# PLANNED UNIT DEVELOPMENT & PLANNING APPROVAL STAFF REPORT

**NAME** The North American Islamic Trust, Inc.

**LOCATION** 63 East Drive

**CONTEMPLATED USE** Planned Unit Development Approval to allow multiple

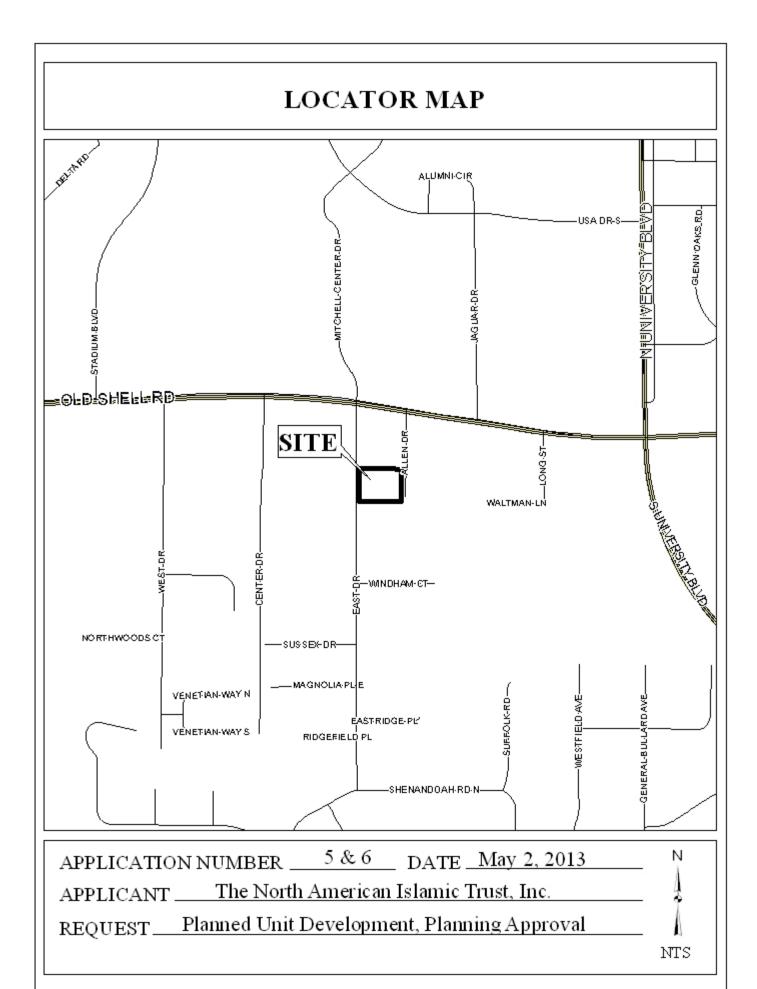
It should be noted that while the site plan submitted shows the phases of development the applicant should provide more detailed site plans for each phase of development. Then a clearer understanding of possible parking issues could be remedied before construction begins. The site plan does not illustrate a dumpster; however, it does provide a note on the site plan stating the owner will utilize curbside pick up..

Also, no buffer is illustrated on the East boundary of the site to serve as a protection buffer to the adjacent residential lots as required by Section 64-4.D.1. of the Zoning Ordinance. In addition, the area indicated as dedicated to the City of Mobile has already been dedicated and thus should be removed from the site and be replaced with the accurate property line boundary along Allen Drive. If approved, a revised site plan should be submitted that shows the entire site in compliance with parking, landscaping, and residential buffer requirements for each phase of development.

A revised site plan was submitted by the applicant. The site plan reflects most of the requested modifications, however, the applicant still proposes approximately 65 parking spaces to be located on site during Phase I development of which 26 would be an aggregate surface. The aggregate surface parking spaces would place the parking ratio short 6 spacesr, these parking spaces would also be a substandard surface.

Ordinarily, this surface would not be allowed; however, for the Phase I development the 9 spaces illustrated between the Mosque and the proposed educational building proposed in Phase II may be allowed to be aggregate until Phase II is completed; however, the 17 spaces illustrated as aggregate should be asphalted during Phase I.

During Phase II, the parking would further be reduced due to the demolition and reconstruction of a larger educational building. As the parking ratio for religious facilities is based on the number of seats within the sanctuary, the seating within the Mosque dictates that 71 spaces be provided. During Phase II the site would provide only 60 spaces; therefore, some type of temporary parking should be implemented during this phase to provide adequate parking during service hours.

While the proposed parking ratio during Phases I and II does not meet the minimum requirements, the reduction is less than 10 percent; the intrusion into the existing residential neighborhood may still pose a concern for neighbors. Expansion of special uses allowed by Planning Approval in residential areas frequently comes at the expense of the residents; therefore, the application as proposed does not meet the requirements for Planned Unit Development and Planning Approval.

<u>RECOMMENDATION</u> Planned Unit Development: Based on the preceding the Planned Unit Development (PUD) request is recommended for denial for the following reasons:

1) the phased development does not provide sufficient parking for each phase which may be detrimental to the neighboring residents.

**Planning Approval:** Based on the preceding the Planning Approval (PA) request is recommended for denial for the following reasons:

1) the phased development does not provide sufficient parking for each phase which may be detrimental to the neighboring residents.
